I am employed as a biologist with the California Department of Fish and Game (DFG) but I am submitting to you my personal comments on the Pacific Lumber Company (PL) Habitat Conservation Plan (HCP). I have attached four letters and memoranda pertaining to the northern spotted owl. All documents are public information. These include my letter to Mr. Mark Stopher dated September 29, 1998 regarding information in the PL HCP pertaining to northern spotted owls, comments to you from Dr. Alan Franklin, Colorado State University, dated October 8, 1998, with his comments on the information in the HCP pertaining to northern spotted owls, a letter to Mr. Roger Thompson, California Department of Forestry and Fire Protection from Mr. Donald B. Koch, California Department of Fish and Game, dated October 26, 1998 pertaining to violations of the Northern Spotted Owl Resource Plan (NSORP), an agreement between DFG and PL intended to govern timber harvest operation while protecting northern spotted owls, and finally a letter to Mr. Tom Herman, Pacific Lumber Company, from you, dated September 28, 1998 regarding a violation of the Spotted Owl Management Plan, an analogous federal agreement to the NS

EXHIBIT 1

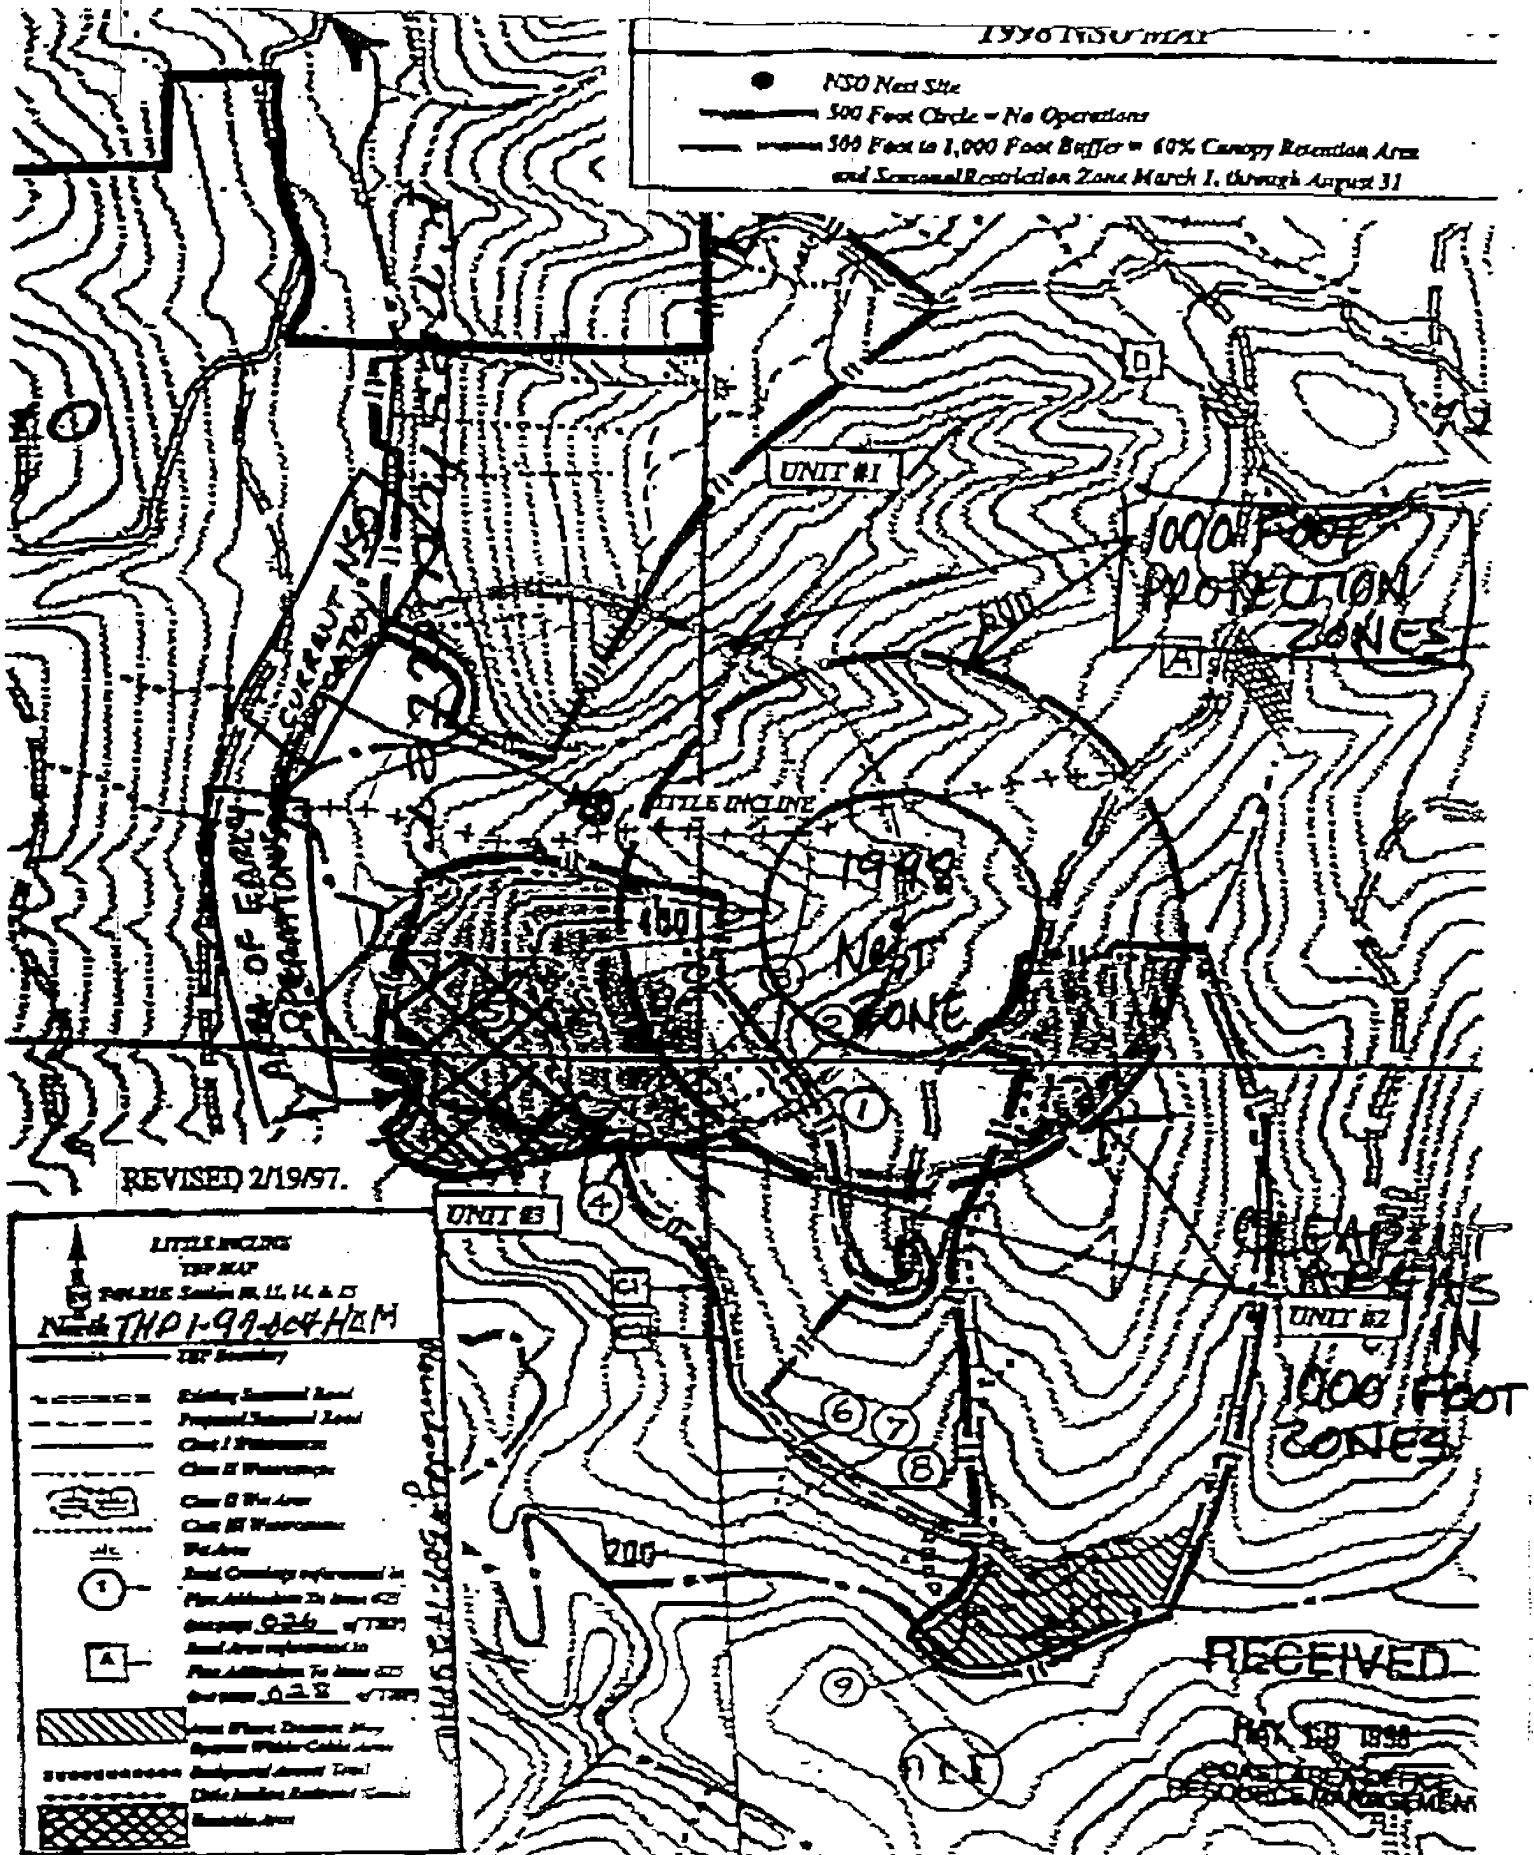
On May 21, 1997, Mr. Sal Chinnici, representing Scotia Pacific Holding Company (SCOPAC), requested in writing approval to clear-cut approximately three acres within the 1,000-foot protection zone of the 1997 nest site (Area A on map Exhibit 1) to clear-cut approximately two acres within the 1,000-foot protection zone of the 1997 nest site (Area B on map Exhibit 1), to add approximately nine acres to the 1,000-foot zone to mitigate for the clear-cut harvesting proposed in the 1,000-foot zone and to construct approximately 600 feet of seasonal road through the 500-foot zone. On September 3, 1997, the DFG provided specific conditions in writing for operations in the 500- and 1,000-foot zones which would accommodate the May 21, 1997, request by Mr. Chinnici and protect the NSO site.

Exhibit 4

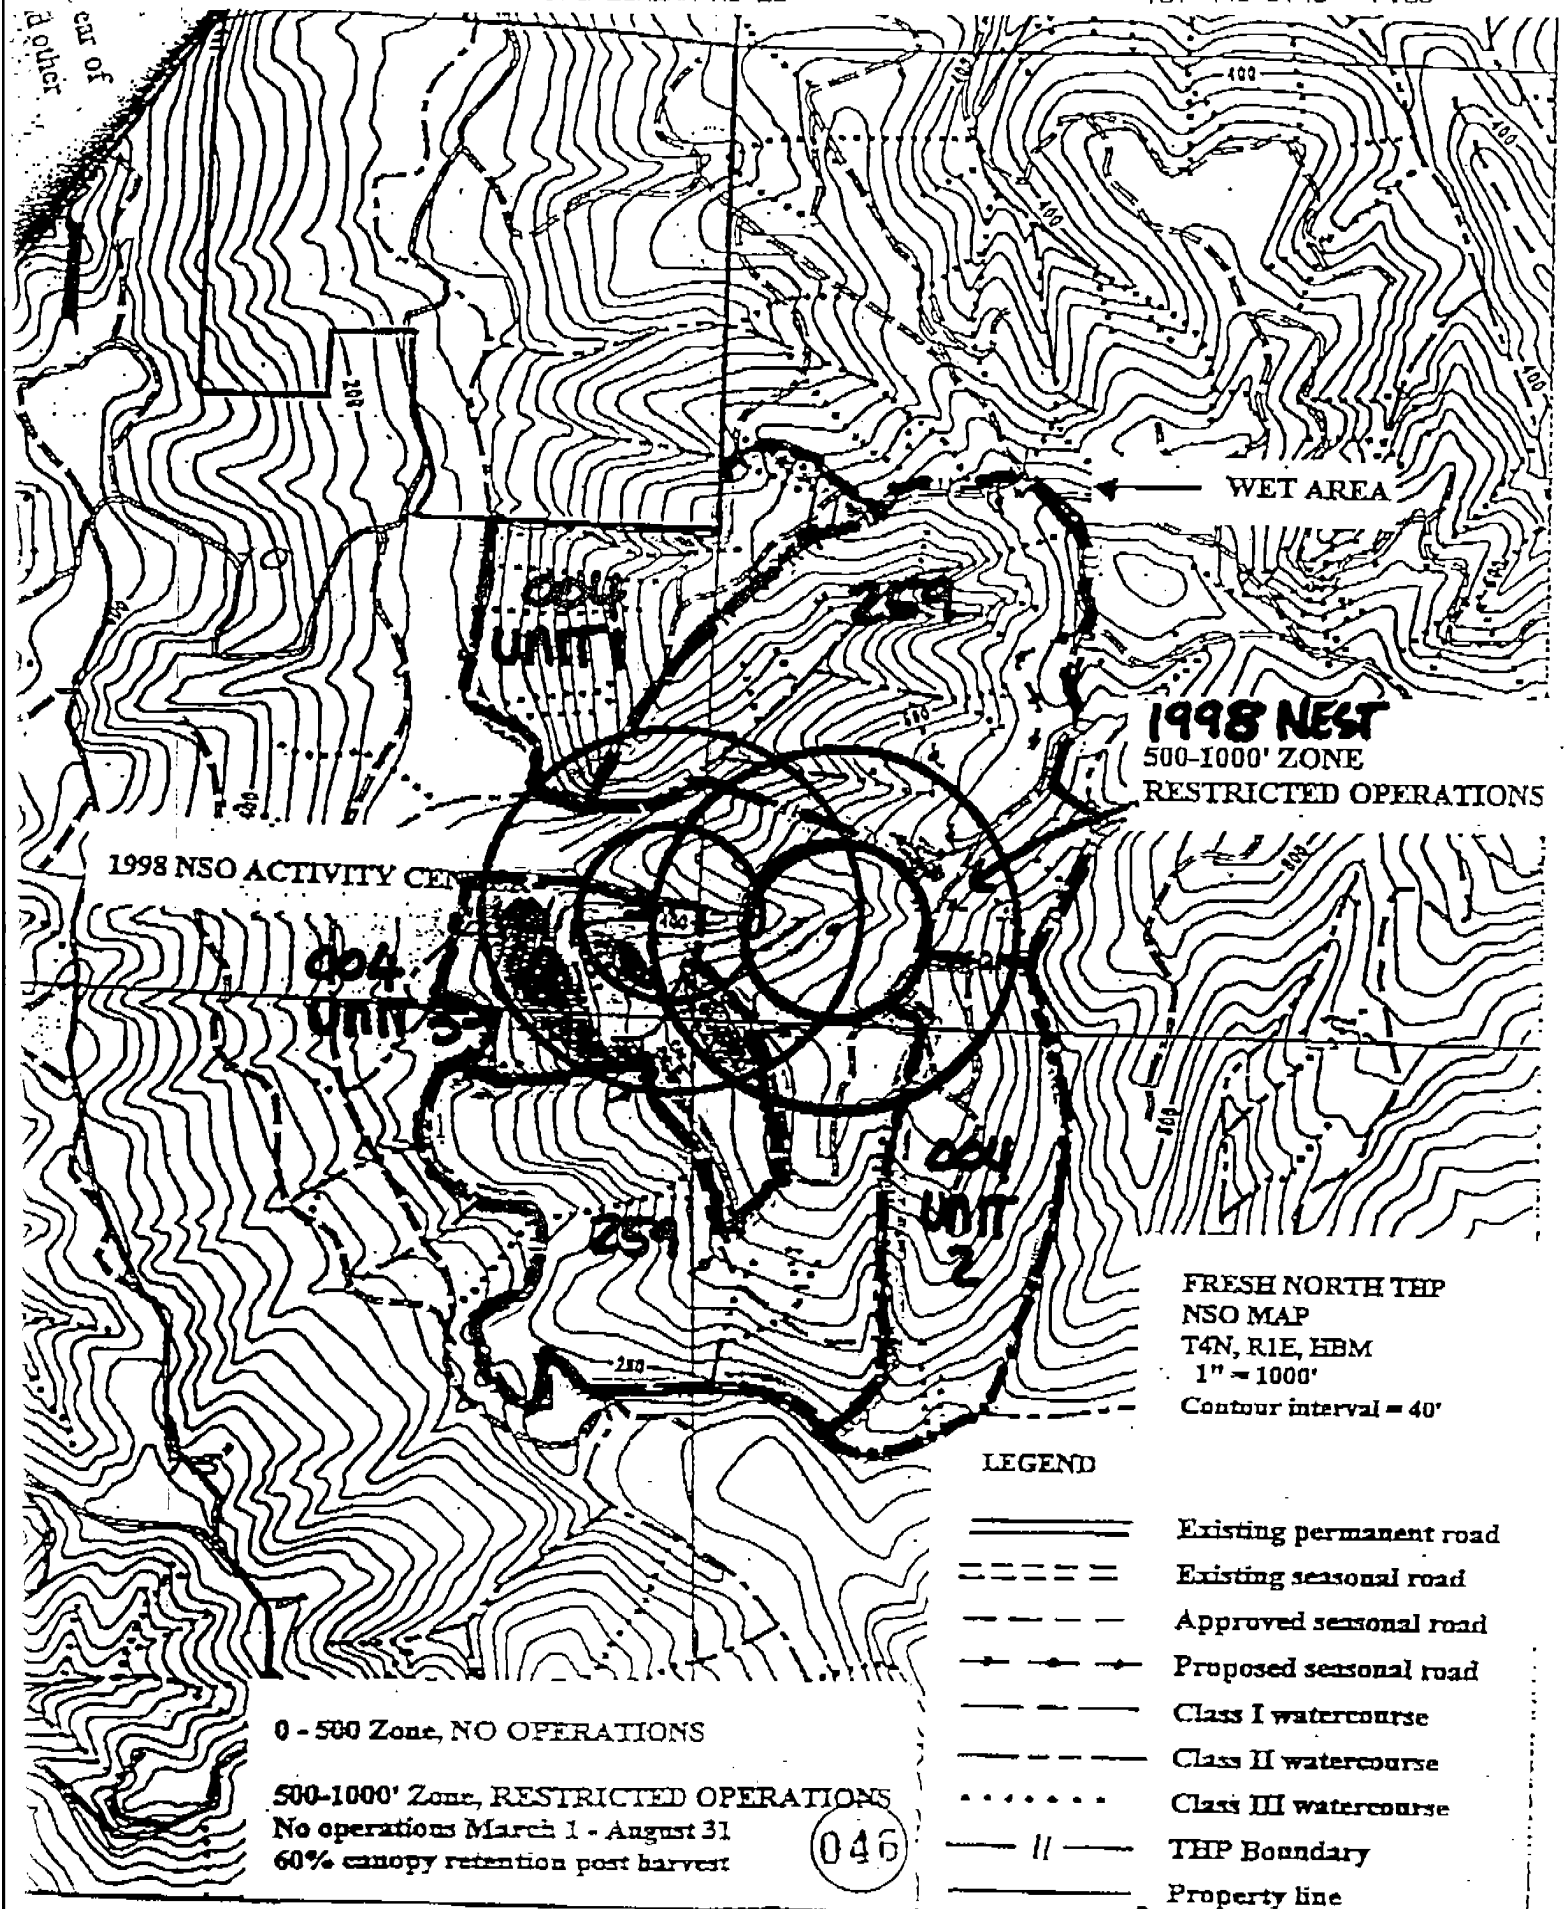
The 1998 nest protection zone (Y) is situated between THP 1-97-004 HUM and THP 1-98-259 HUM (see Exhibit 4) with the 1,000-foot zone overlapping portions of both plans. The 500-foot no-operations zone around the nest tree overlaps only THP 1-98-259 HUM. In addition to the 1,000-foot zone being deficient by approximately 150 feet, the canopy retention standard requiring an average 60% in the 500- to 1,000-foot radius around the nest appears deficient. The DFG and the CDF agreed to try to identify a methodology to assess the canopy retention in this zone by October 23, 1998. We also agreed to try to actually conduct the assessment by October 30, 1998.
